Consultation report of the public consultation on the scenarios, sensitivities and data for the CRM parameter calculation for the Y-1 Auction with Delivery Period 2026-27, Y-2 Auction with Delivery Period 2027-28 and Y-4 Auction with Delivery Period 2029-30

June 2024

Figure 4: Comparison of the HDD calculated based on Copernicus and Metéo France 2025

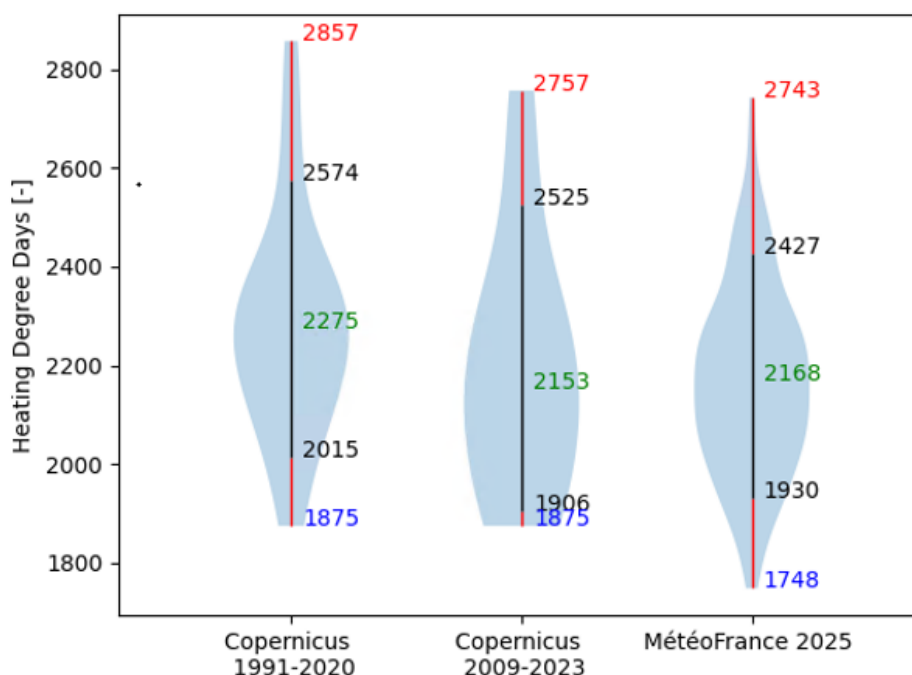
CREG	La CREG demande à Elia d’indiquer la date de la dernière mise à jour de la base de données de Météo France. La base de données climatiques devrait prendre en compte le changement climatique et le réchauffement de la planète. Comme les années climatiques ne sont pas publiées, rien ne prouve que les années climatiques prospectives sont réellement représentatives. La CREG aimerait voir comment les années historiques récentes peuvent être intégrées dans la base de données climatiques.
Febeliec	Febeliec strongly regrets that Elia still does not involve the stakeholders in the development of this methodology, other than the stakeholders imposed by the law (FPS Economy plus coordination with CREG). Febeliec will provide its comments on the consultation but this does not mean that Febeliec agrees with the applied methodology and should in no case be interpreted as such.
Febeliec	Febeliec wants to reiterate its longstanding position regarding the calculation being conducted for just one scenario, with only one specific subset of sensitivities being selected. While Febeliec understands that in the end one final scenario has to be selected for the calibration, Elia could still conduct calculations for multiple scenarios which would allow much better insight in the sensitivity of the results regarding the changes in the scenario. Even though no legal obligation exists for such additional calculations, there also does not exist a legal prohibition for such calculations and they would deliver essential insights for a thorough analysis and selection of the final scenario to be applied. Febeliec insists that it would be wise and prudent to run at least some alternative scenarios, even though there is no legal obligation, in order to provide the necessary relevant input for any governmental decisions.

Regarding the question of the CREG on the Météo France climate database, Elia utilises a climate database generated for the target year 2025, as described in Annex J of Adequacy and Flexibility study 2024-2034. The climate change and in particular the increase of the temperature can be observed by analysing the evolution of the HDD. The Figure 4 shows the historical HDD for the period 1991-2020, the historical HDD for the period 2009-2023 and the HDD calculated based on the Metéo France for 2025. The HDDs are computed using the formula developed by SYNERGRID. Note that SYNERGRID relies on the temperature measurement at Uccle. However, in this analysis, the population weighted average temperature in Belgium is used. The HDD calculated based on the Météo France for 2025 follows the expected trajectory.

Figure 5: Overview of small-scale battery capacities

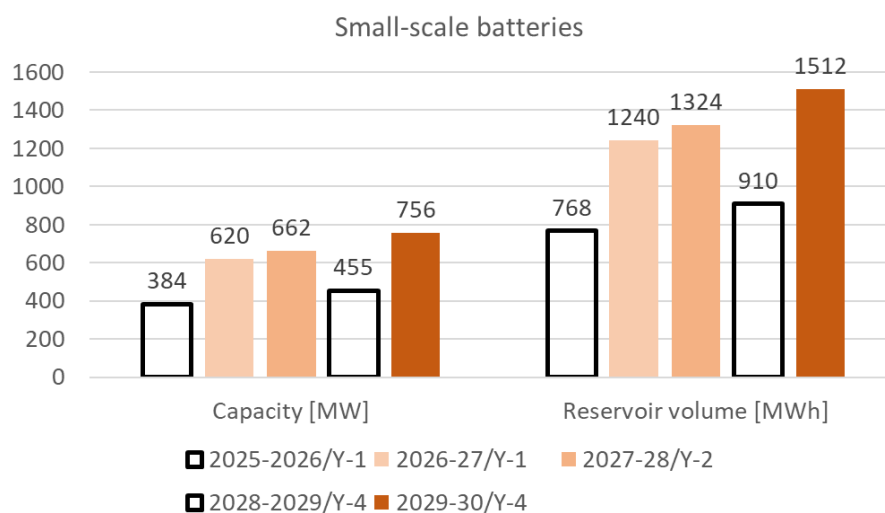
CREG	Pour les batteries ‘small-scale’, Elia indique qu’elle considère qu’une capacité supplémentaire équivalente à 0,3 % de la capacité photovoltaïque installée existante totale sera installée (contre 0,2 % dans l’étude Adequacy & Flexibility 2024-2034). La CREG demande à Elia de préciser le choix de cette hypothèse d’évolution par rapport à l’étude Adequacy & Flexibility.
FEBEG	FEBEG welcomes the split between large-scale batteries and small-scale batteries. We however wonder to which extend the hypotheses regarding the split of in-market and out-of-market for small scale batteries are realistic and question the amount of in-market small-scale batteries.
Febeliec	Moreover, Febeliec is surprised by the proposal of Elia for small scale storage, as currently many new and existing players are active in this domain and the business cases for such batteries, even without CRM, have become very positive. Febeliec considers the proposal from Elia for small scale storage an underestimate and thus not in line with the legal lowest cost criterion.

First, Elia would like to point to an inconsistency in the dataset. The capacities of the small-scale batteries presented in the assumption workbook and in the explanatory note were incorrect. The capacities presented in the slides were correct. The correct values are presented in the Figure 5 below.

Elia updated the percentage of installed small-scale battery capacity compared to the total solar capacity because the installation rates of small-scale batteries in 2022 and 2023 were much higher than expected. High installation rates due to government support were expected but surpassed in 2022 and 2023. This leads Elia to believe it underestimated the adoption rate of small-scale storage, without subsidies. In addition, battery prices have fallen sharply over the
